**CITY OF AUSTIN
Board of Adjustment
Decision Sheet**

CASE NUMBER: C15-2017-0047

ADDRESS: 3602 & 3604 RIVERCREST DR

VARIANCE REQUESTED: The applicant has requested variance(s) from Section 25-2-1176 (Site Development Regulations for Docks, Marinas, and Other Lakefront Uses) (A) (1) to increase the distance a dock may extend from the shoreline from 30 feet (required/permitted) to 60 feet (requested) in order to construct a new dock in an "LA", Lake Austin zoning district.

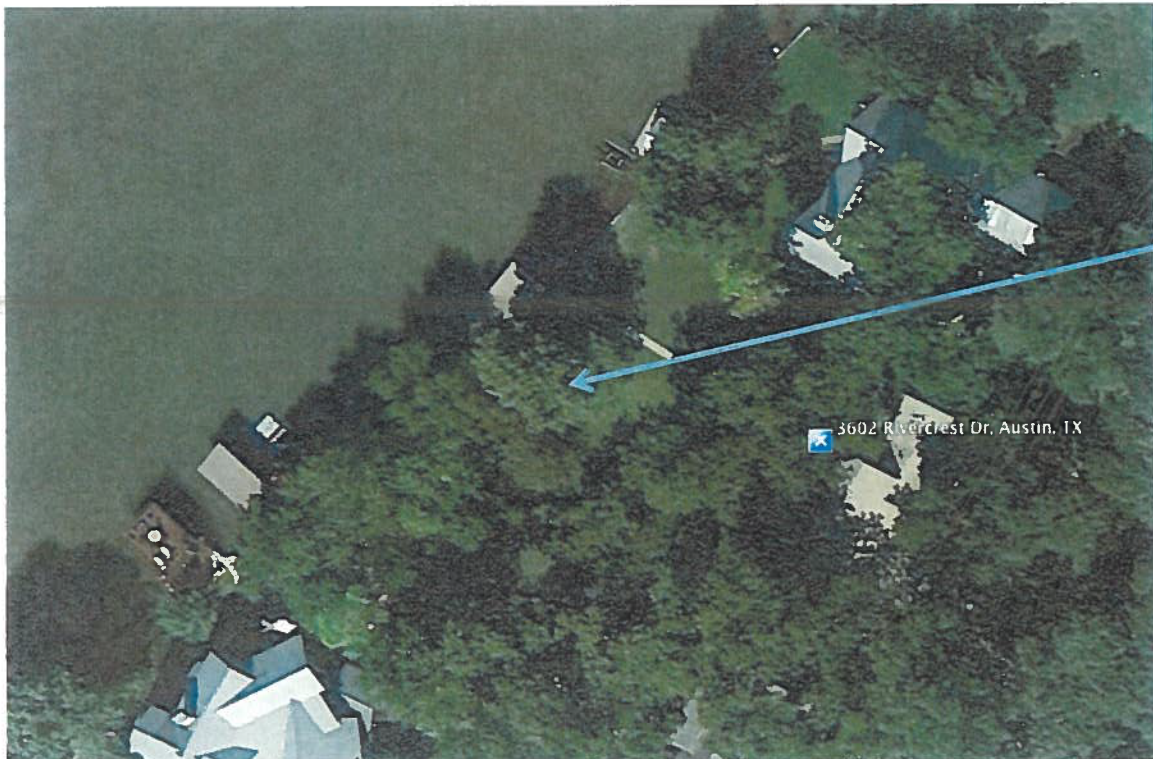
By City Code, there can be no cut or fill greater than 4-inches in the Half Critical Root Zone ($\frac{1}{2}$ CRZ) with **no impact** to be had within the One Quarter Critical Root Zone ($\frac{1}{4}$ CRZ).

With the tree located at 23-feet 8-inches from the bulkhead on the lake, the entire area between the tree's trunk and the bulkhead is within the $\frac{1}{2}$ CRZ (25-feet from the trunk.)

The current proposal before the homeowner is to remove the existing bulkhead and return the shoreline of Lake Austin back to it's original position which would be within 4 or 5 feet of the trunk of this Heritage Tree. This would also negatively impact negatively the $\frac{1}{4}$ CRZ by more than half ($\frac{1}{4}$ CRZ = 12.5 feet.)

If as much as 60 to 70 % of the $\frac{1}{2}$ CRZ were to be removed, the tree would be potentially mechanically unstable. On the east side of lake exposed to high wind events, the resulting root destruction could topple the tree back towards the house.

3602 & 3604 Rivercrest Drive

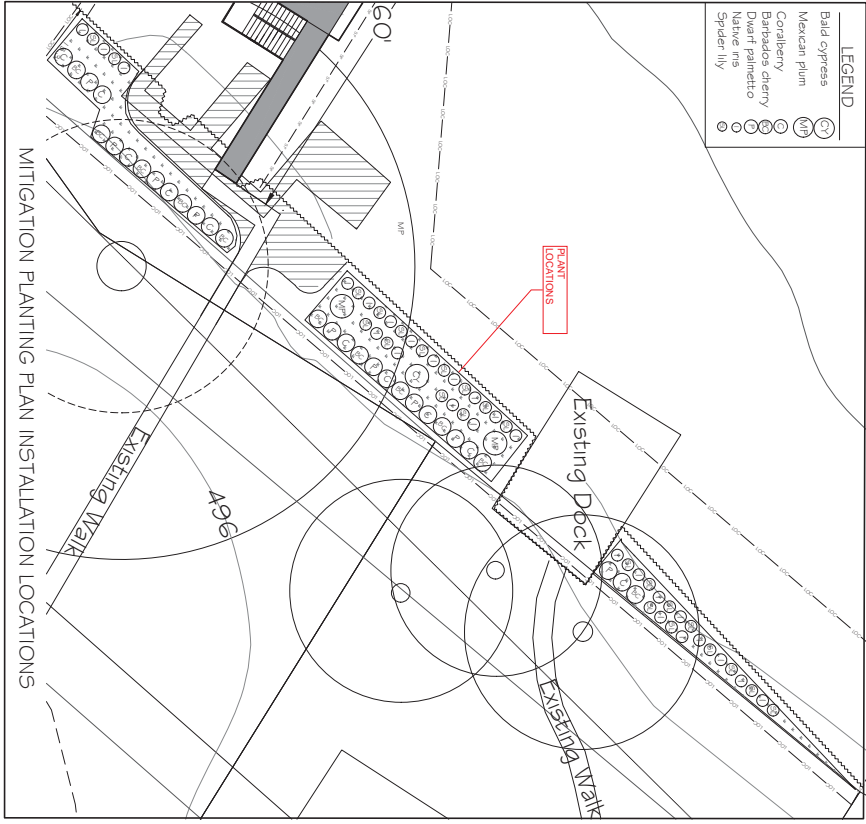
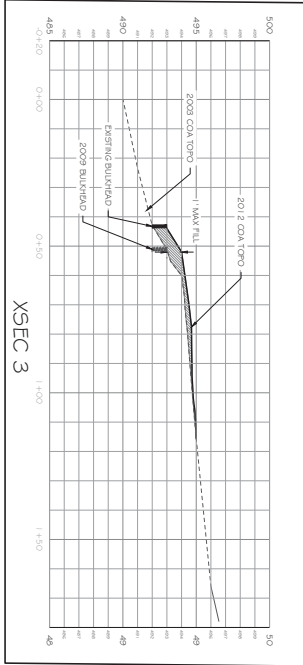
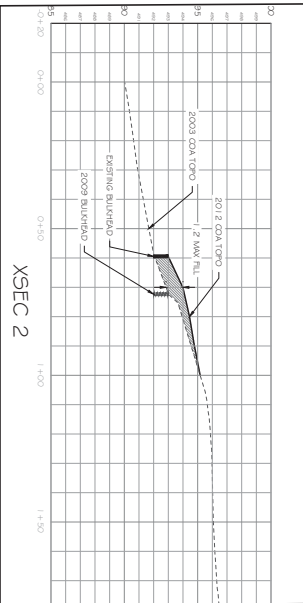
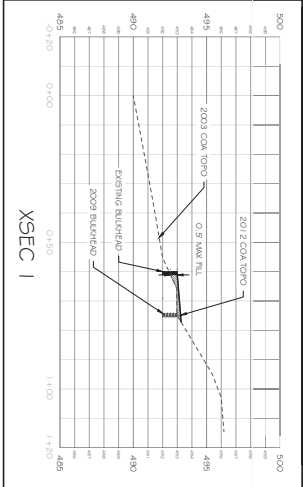
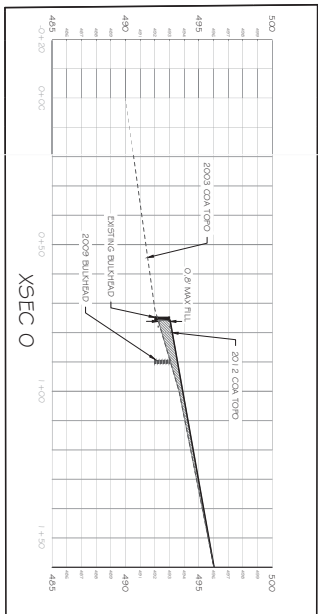
WB 3 Update 0 Provide accurate bathymetric profile information demonstrating how the 20 cubic yard dredging estimate was calculated.

Update 1: Show the dredging profile on the architectural elevation. **SEE SHEET 2**
